## **Thanet Extension Offshore Wind Farm**

Appendix 2 to Deadline 2 Submission: Applicant's  
Response to Written Representations on the  
theme of Ports/Shipping Routes

Date: February 2019

**Figure 1: Schematic of LPC Sea Room Calculation for 400m length and 50m beam vessel**

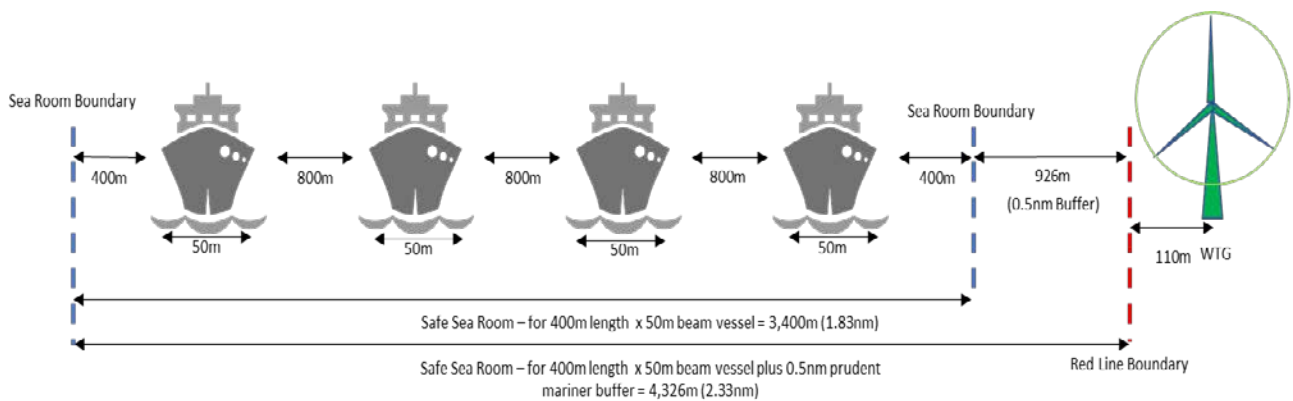
- 21 When considering how to determine the minimum safe searoom the Applicant would draw the ExA's attention to the LPC's representations, with regard to necessary sea room for a shipping route, as calculated through reference to MGN543 (Section 10.3, MGN Compliance at pg 6 of the LPC Action Point document, REP1-104), where sea room calculations are made on the basis of a vessel with length of 400m and a beam of 50m, and are referenced to the shipping route to the north of the proposed TEOW passing through the Tongue pilot boarding station.

The LPC calculation for four 400m length and 50m beam vessels is as follows (see

- 22 Figure 1 for schematic representation):

- 4 x 50m beam = 200m
- 2 x 400m length clearance to edge of route = 800m
- 3 x 400m length between four vessels = 2,400
- Safe sea room = 3,400m (1.83nm)

- 23 In the following sections the Applicant utilises the calculations presented by LPC, drawing on the empirical data noted above regarding maximum vessels sizes currently using the routes.

**Figure 2: NE Spit Sea Room Distances – (Appendix 28, Annex B to Deadline 1 Submission: NE Spit Sea Room).**

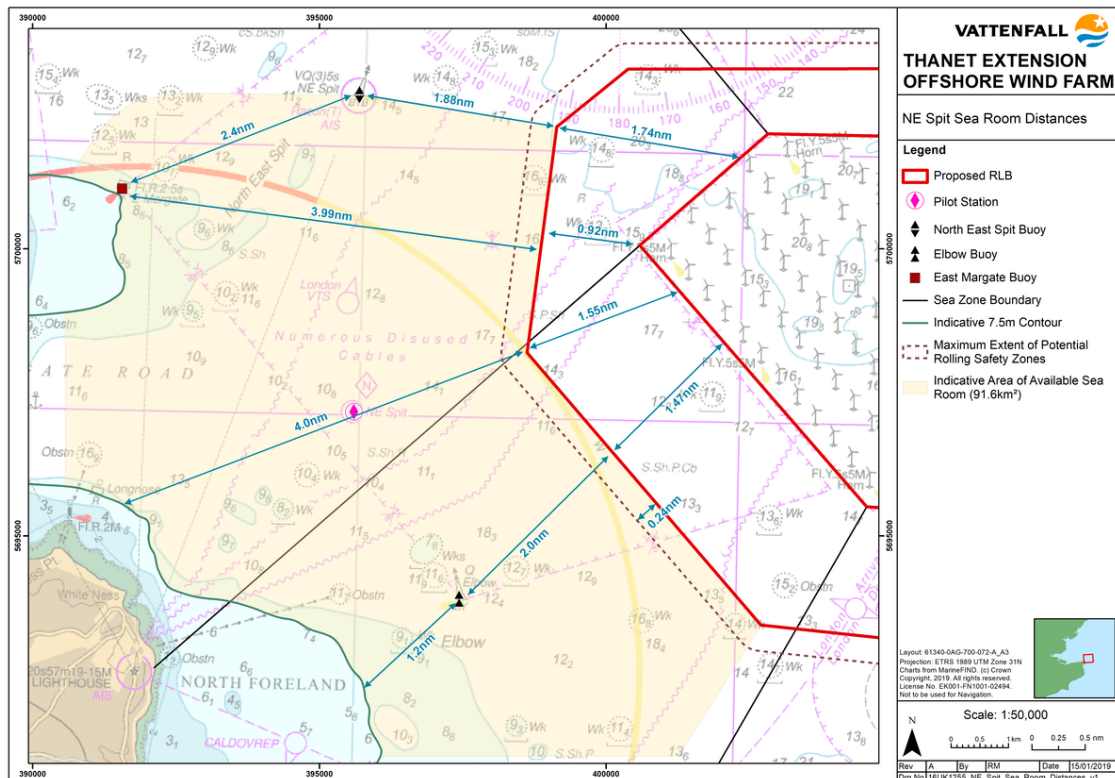
- 20 When considering sea room the Applicant notes its Deadline 1 submission – NE Spit Sea Room Distances – presented at Figure 2 - which shows sea room distances to the west of the proposed TEOW Red Line boundary (RLB). The Applicant also notes that there has been no evidential / empirical basis for the reduction in RLB requested by any IP (except from LPC where empirical calculations are documented – but not expressed for either the inshore route or for “dipping” traffic).

- 28 When reference is made to the sea room plot at Figure 2, and submitted at Deadline 1, where a sea room distance from the Elbow cardinal mark to the TEOW RLB is presented as 2.0nm, then it is evident that the inshore route sea room remains appropriate based on LPC calculations.

Figure 3: Route Deviations

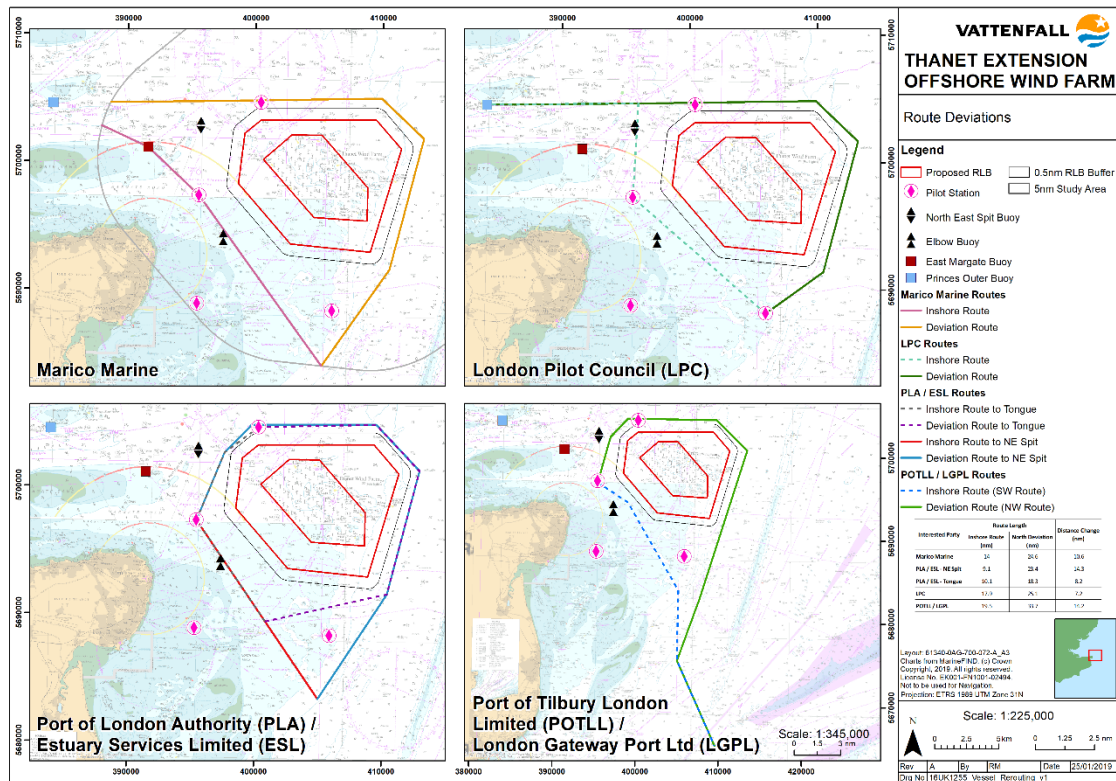
- 38 However, the PLA and ESL WR contest the distance put forward by the Applicant as representative of any increase in journey re-routeing, and in their view this is closer to 14nm which assumes that the vessel would “dip” down into North East Spit boarding area to take a pilot. It is however counter intuitive for a vessel that actively chose not to navigate the inshore, would then “dip” down (into the inshore route) to take a pilot, and would more likely request a pilot at either the Tongue or NE Goodwin pilot boarding stations. In addition to this Port of Tilbury / DPWLG also identify a similar distance to PLA /ESL of 14.4nm. (see Figure 3).

- 39 The LPC, appear to take this on board, that a rerouted vessel would not elect to “dip” to take a pilot as they assume when taking a passage from NE Goodwin the additional distance will be 7.8nm. This distance is less than the Applicant calculated, as LPC chose to commence the reroute from the NE Goodwin Pilot boarding station, and shows inshore route transiting to the east of the NE Spit RACON / Cardinal mark – which has some validity for larger draught vessels only.

- 40 Part of the reason for these discrepancies, is the assumed start and end point of the deviation. Notwithstanding the potential economic effect associated with the re-routing as raised by LPC in their response, it should be noted that Port of Tilbury, PLA and ESL all assume vessels would 'dip' back into the NE Spit pilot station. This assumption requires a vessel master to pass by NE Goodwin and the Tongue pilot stations in order to get to NE Spit. This appears to be an overtly conservative assumption that is unlikely to be borne out, in particular given the Applicant's firm view that pilotage operations are evidentially able to continue, as recorded within the pilotage simulation.

- 41 On this basis and considering the variation in assumed distances submitted at Deadline 1, the Applicant maintains that an assumed re-routing for pilotage operations of 11nm for vessels that chose to reroute from the inshore route is a reasonable basis for the purposes of assessment, noting however the Applicant does not agree that vessels would need take this diversion.

Figure 4 Chartlet showing Fishermans Gat

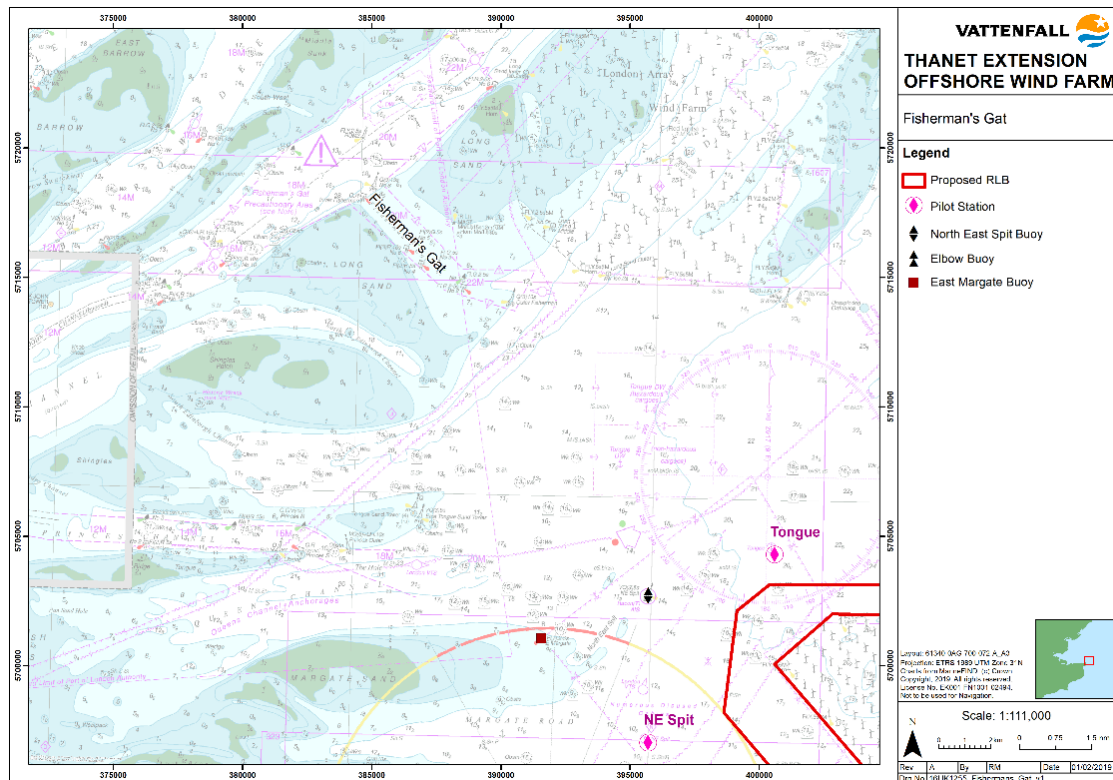
- 44 Specifically, the PLA and ESL have noted that *“the key potential works which could be undertaken by the PLA over the lifetime of the extended Wind Farm would be the potential dredging of either Fisherman’s Gat or the North Edinburgh Channel”*. The Applicant can confirm, as identified within the Applicant’s responses to ISH2 Action Point (REP1-012), that following a review of the MMO’s MCMS there is no current record of a project of this nature on the Public Register. As such this would not be a material consideration within the cumulative effects assessment undertaken for Thanet Extension.

- 45 Notwithstanding this clarification the Applicant notes that the area mentioned also falls outwith the TEOW study area to the north-west. Fisherman’s Gat does not appear visibly on the Applicants Deadline 1 submission (Nautical Chart; REP1-025) but is illustrated below for the benefit of the ExA, and can be seen to the north-east of N Edinburgh Channel which falls just to the west of the Princes Channel ‘seazone’ demarcation line as illustrated on the Applicants REP1-025 submission.

- 46 The Applicant would also make the observation that the Fisherman's Gat area falls within the Margate and Long Sands Special Area of Conservation which would present a significant environmental barrier to a large scale dredging operation in this area.
